Architect Name and Address	BAY LAKE, FLORIDA 32830
G.C Name and Address	
Project Name and Address

Scope Description	AREA	GROUP	SERIES
			COVER SHEET

Drawn By	Date
HD	09/27/19
Project #	Submittal #
3403	01
Drawing #	
00CS

1 PLAN SECTION - SERVING AREA 104
SCALE: 3/4"=1'-0" ARCH REF: E6/A-321

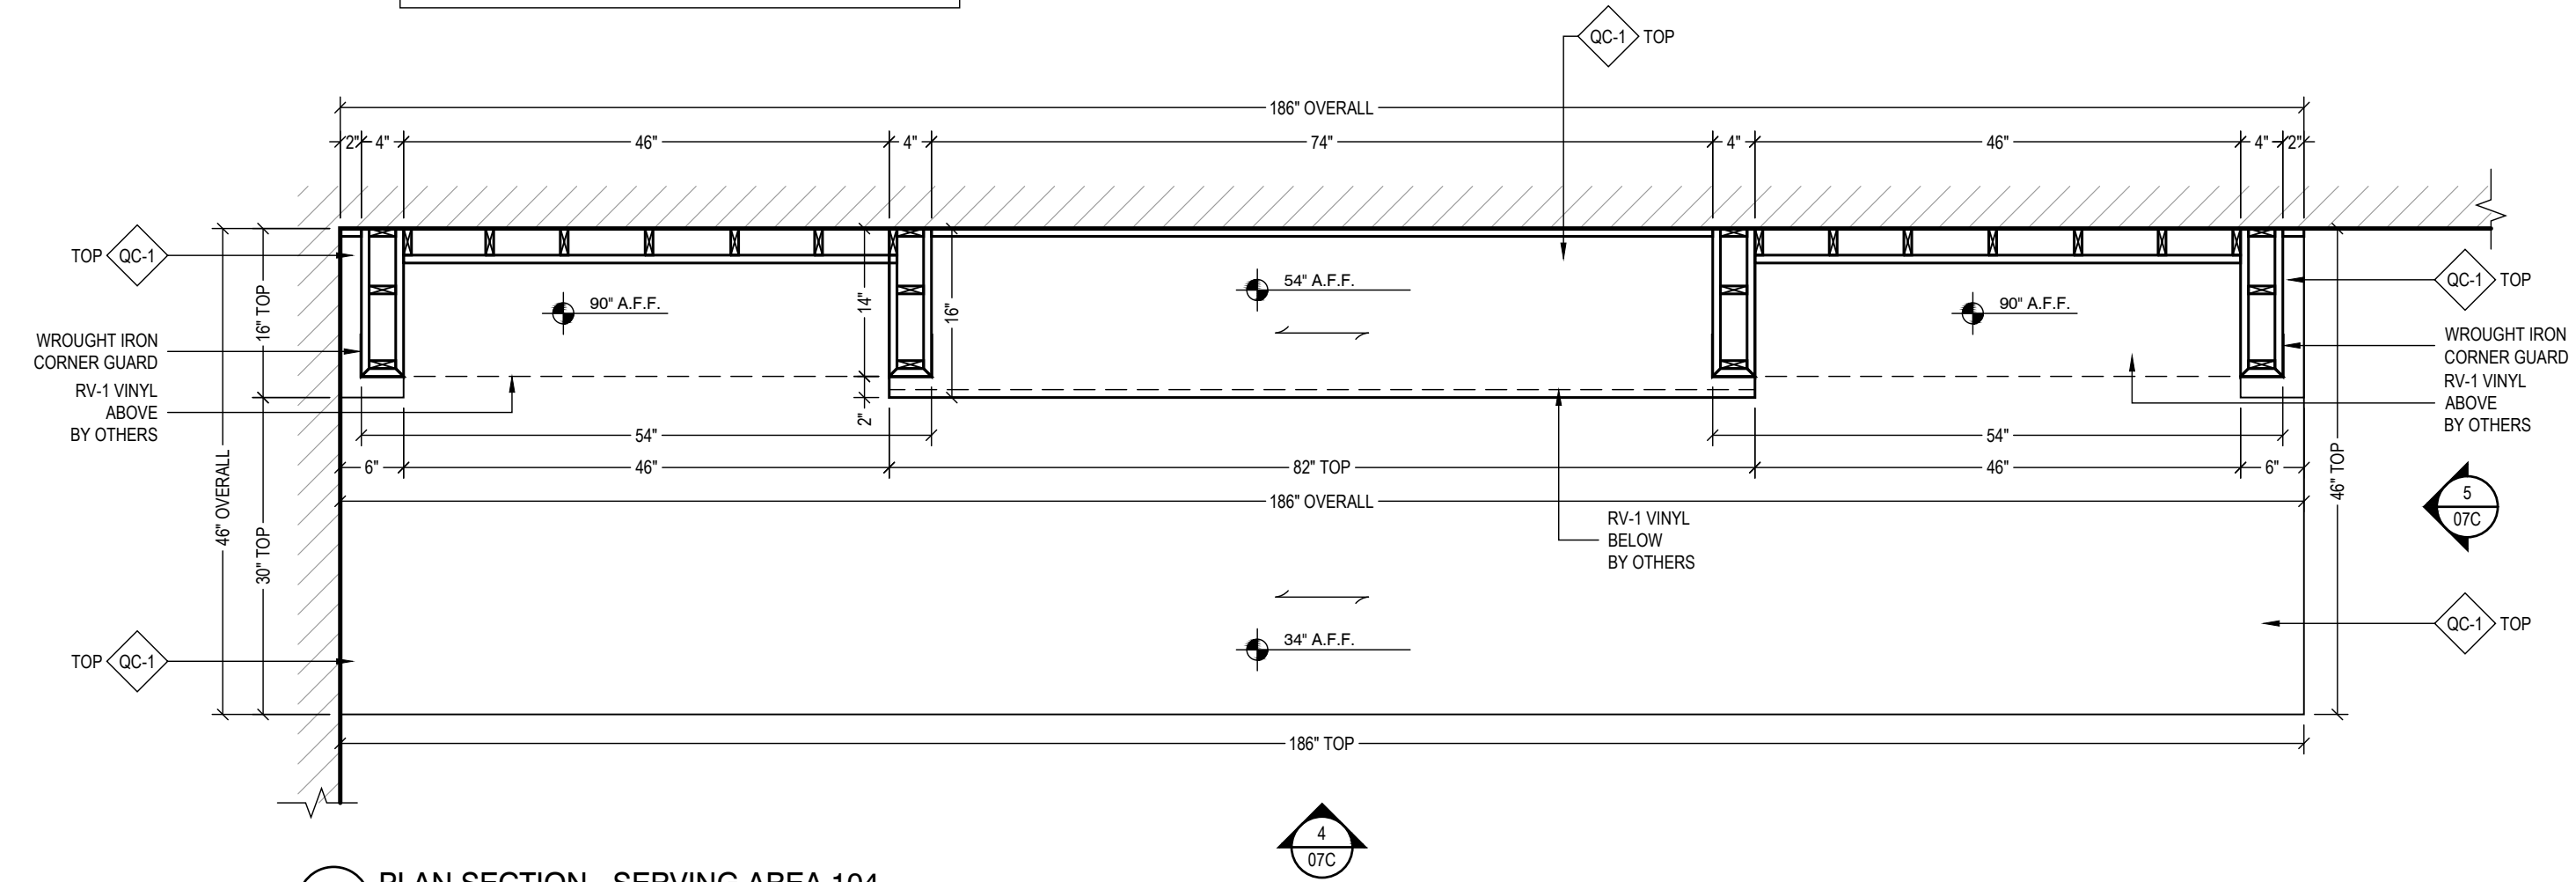
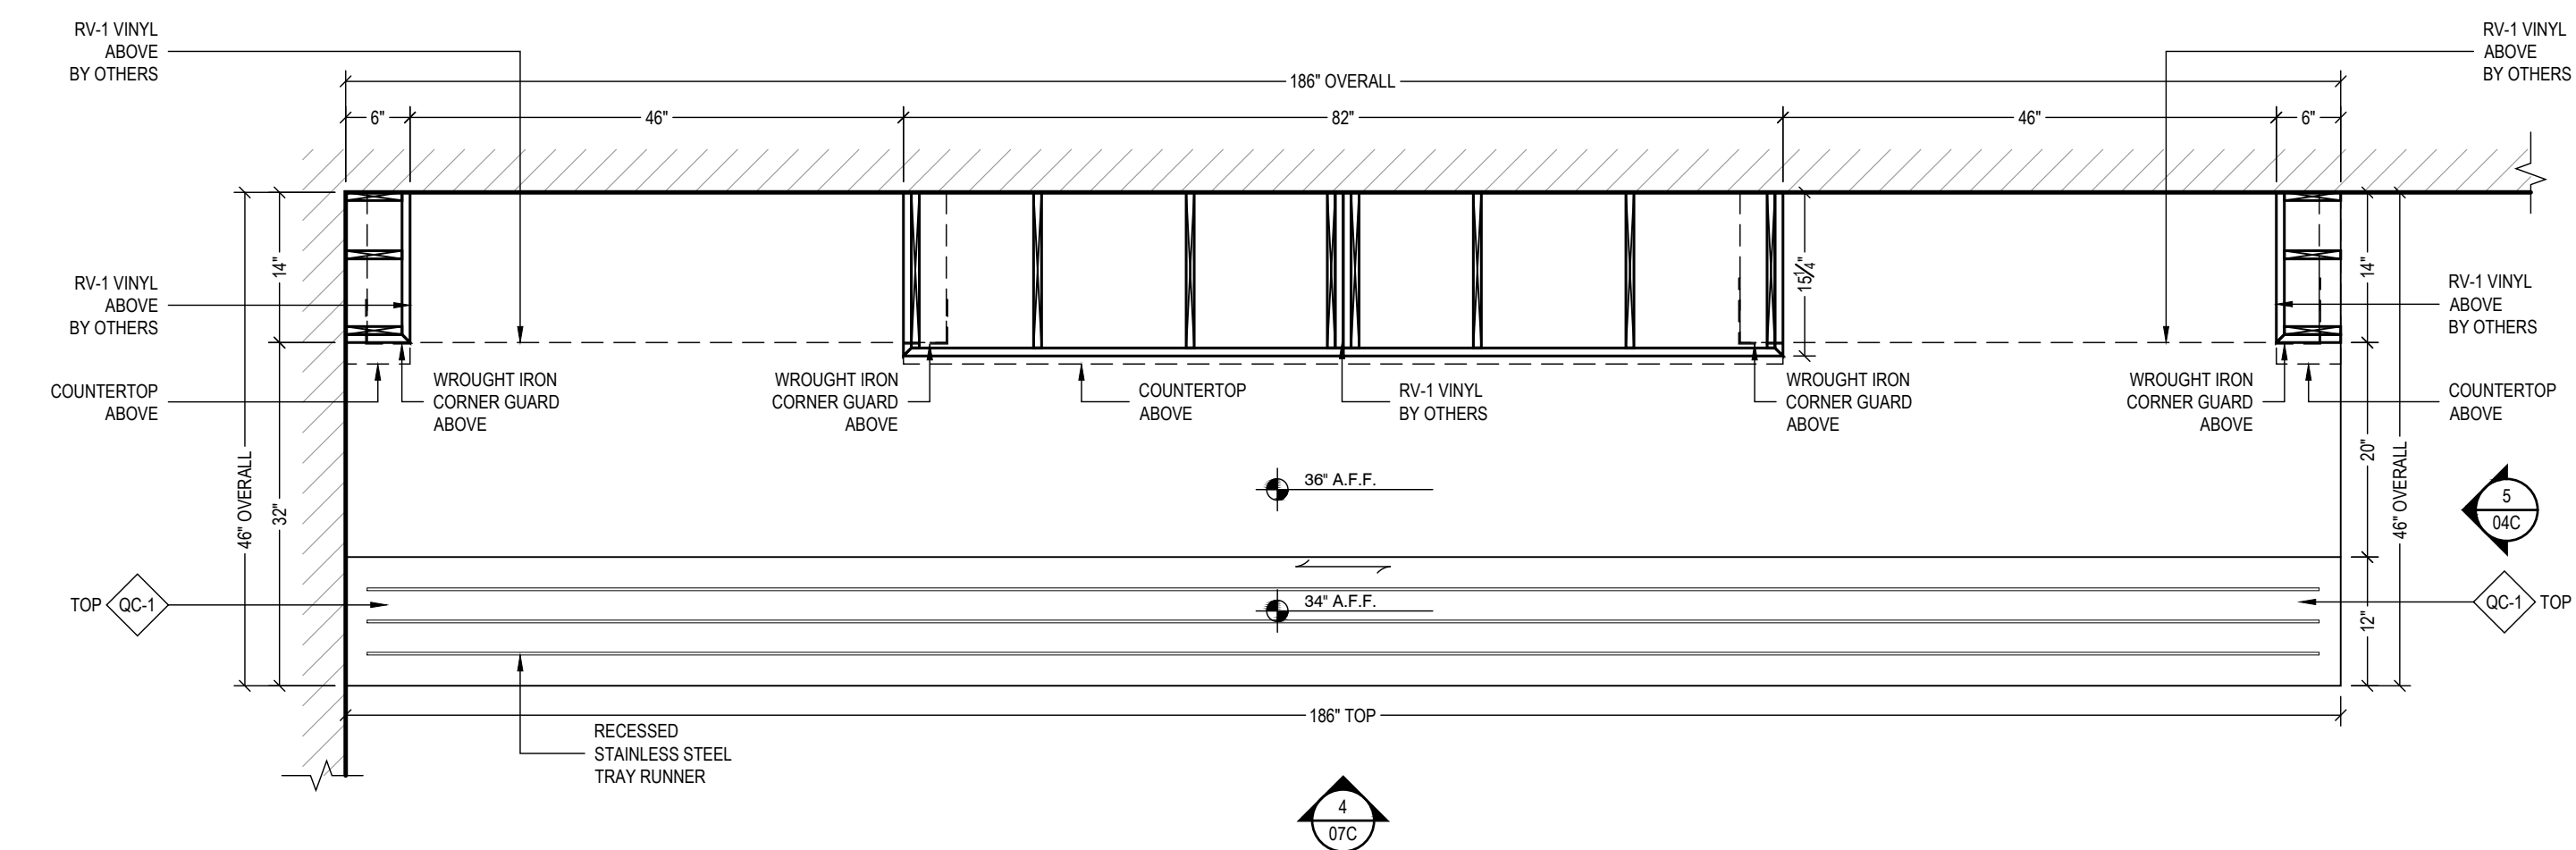
REDLINE NOTE
WDI TO CONFIRM DESIGN SCOPE
FOR SERVING AREA MILLWORK
